Subject: UniStar Nuclear Energy, NRC Docket No. 52-016  
Response to Request for Additional Information for the  
Calvert Cliffs Nuclear Power Plant, Unit 3,  
RAI No. 110, Offsite Power System

**Response to NRC Request for Additional Information  
RAI No. 110,  
Questions 08.02-1 and 08.02-2 and Questions 08.02-4 through 08.02-8,  
Offsite Power System  
Calvert Cliffs Nuclear Power Plant, Unit 3**

**RAI No 110**

500kV TANGENT  
CENTERLINE SPACING  
MAX. STR. HEIGHT OF 130'

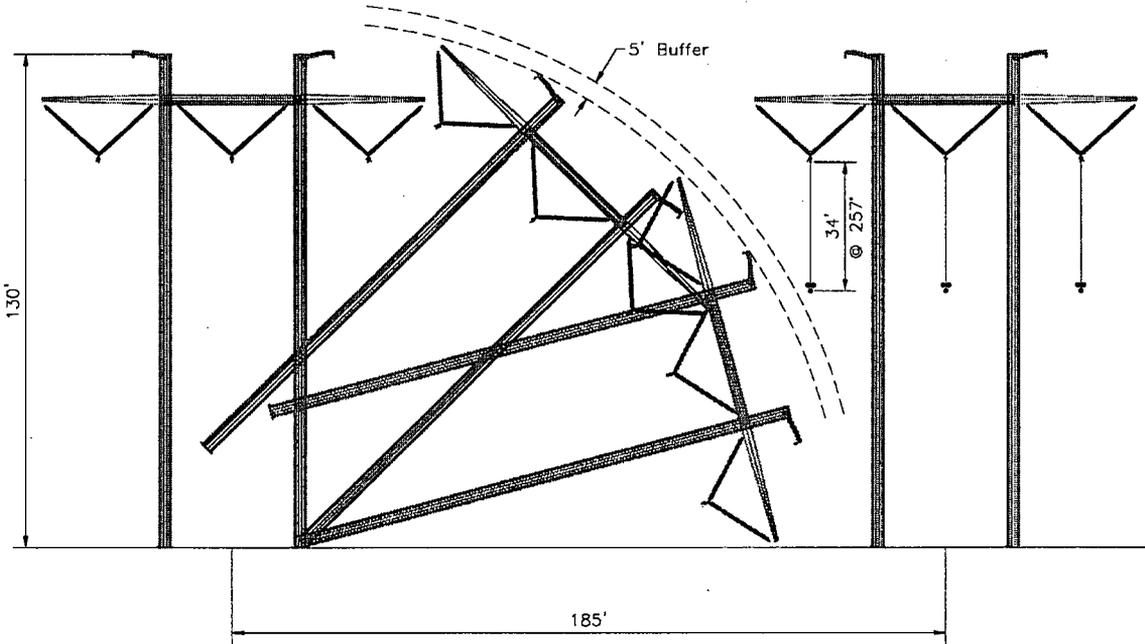
Section 8.2.1.1, page 8-11 of FSAR:

Indicates that the CCNPP3 design contains “four normally energized, physically independent transmission lines, designed and located to minimize the likelihood of their simultaneous failure under operating, postulated accident and postulated adverse environmental conditions including transmission line tower failure or transmission line breaking”. In view of this statement, the staff reviewed the 500 kV Switchyard and Transmission line Layout drawing 8.2-1. This drawing shows the four new overhead transmission lines are laid parallel in close proximity with each other on one right-of-way. The close parallel runs show apparent vulnerability to severe natural phenomena or weather events which can cause simultaneous failure such as tower collapse or line breaking. Address this staff concern and provide a highlight of the design bases for the SSCs to reflect appropriate consideration of the most severe of the historically reported natural phenomena. The applicant is requested to amplify their discussion of compliance with the requirements of GDC 2 and 4 to specifically address this concern. This discussion should confirm that the transmission tower separation, line installation, and clearances are consistent with the National Electric Safety Code (NESC).

The 500KV transmission line towers for the four lines originating from the CCNPP3 500KV Switchyard will be installed by Baltimore Gas and Electric (BGE) and spaced such that even if a tower collapses due to severe natural phenomena it cannot fall on the adjacent line or tower. A typical sketch of a falling tower indicating adequate clearance to adjacent lines is provided. This sketch indicates that there is no vulnerability of the 500KV Transmission Line Layout shown in FSAR Figure 8.2-1. Installation and clearances are consistent with the National Electric Safety Code.

This configuration ensures that appropriate considerations were applied to the design bases of the SSCs important to safety. These considerations include severe natural phenomena, the combination of effects of normal and accident conditions with the effects of severe natural phenomena, and the importance of the safety function being provided. Additional consideration was given to the environmental conditions associated with normal operation, maintenance, testing and postulated accidents, and the protection of the SSCs to ensure compliance with NRC GDC 2 & GDC 4.

CCNPP Unit 3 FSAR Sections 8.2.2.1 and 8.2.2.2 incorporate by reference the U.S. EPR FSAR Sections 8.2.2.1 and 8.2.2.2 discussion of GDC 2 and 4 for offsite power. FSAR Section 8.2.2.4 Subsections titled “Transmission Line Tower Failure Mode Evaluation” and “Transmission Line Conductors Failure Mode Evaluation” indicate compliance with the National Electrical Safety Code in the analysis. Therefore, no further discussion of the topic is provided in the FSAR.

CALVERT CLIFFS UNIT 3  
 500KV SWITCHYARD  
 TYPICAL PROTECTION SINGLE LINE  
 FIGURE 1

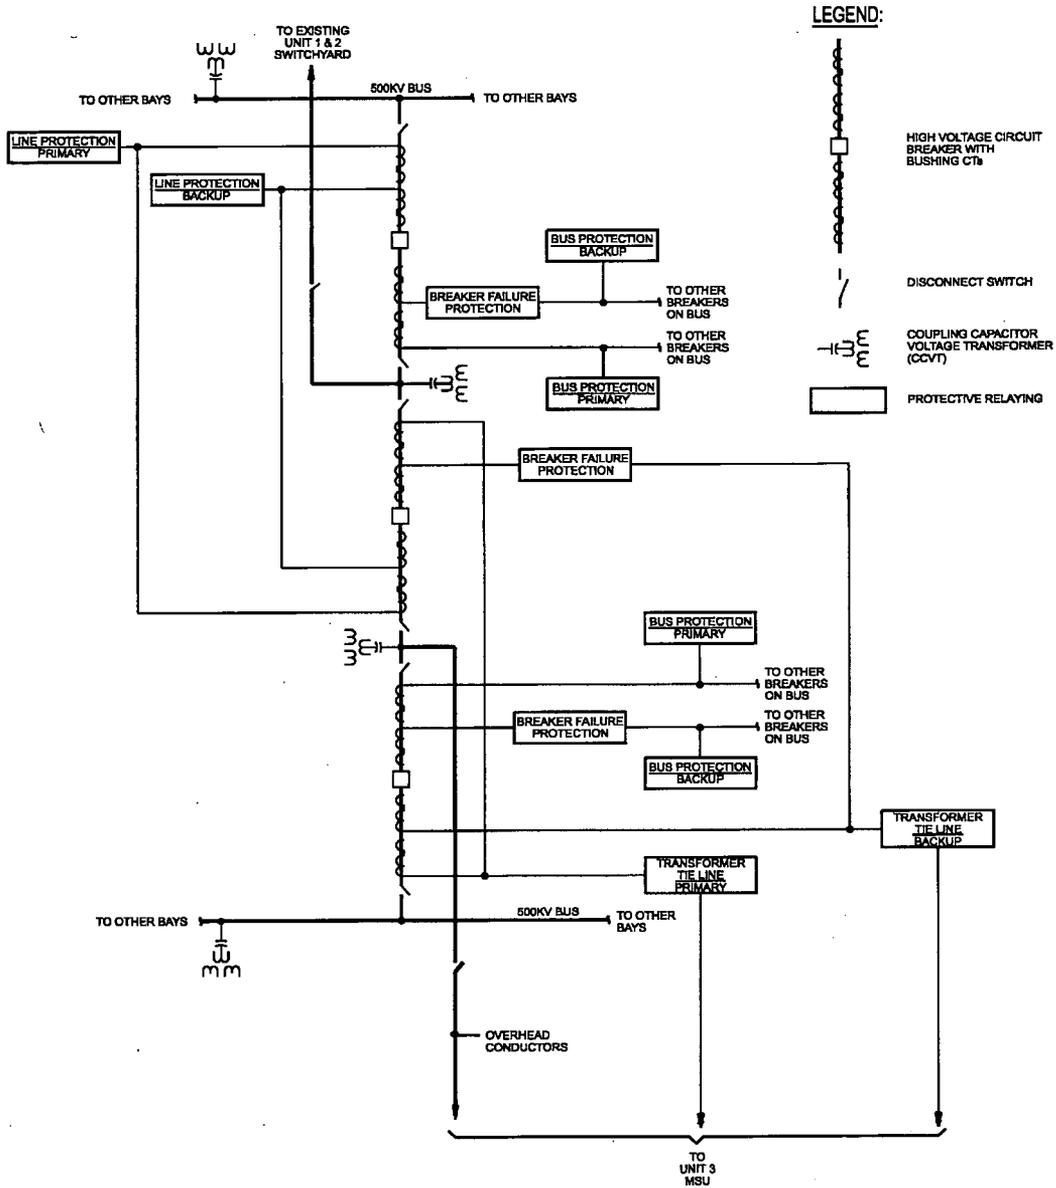
Section 8.2.2.4, page 8-20 of FSAR: 500 kV switchyard primary and secondary relaying system  
- Provide a relay protection scheme/single line diagram for understanding of the primary and secondary protection scheme and zone of protection. Explain how the typical zone of protection will include main step up transformers, essential auxiliary transformers and normal auxiliary transformers.

COLA FSAR Subsection 8.2.2.4, page 8-18, provides under "Switchyard Failure Mode Evaluation", a section describing the breaker-and-a-half switchyard arrangement and the primary and secondary relay protection system. Attached Figures 1, 2, and 3 provide typical protection diagrams for the main step up transformers, essential auxiliary transformers and normal auxiliary transformers indicating overlapping protection zones. Each outgoing line to the grid is protected by redundant transmission line protection schemes. Each bus is protected by redundant bus differential protection. Each line between the switchyard and the plant transformers is protected by redundant tie line protection schemes. Each transformer is protected by redundant protection schemes. Faults within the transformers will trip the switchyard breakers to isolate the transformers.
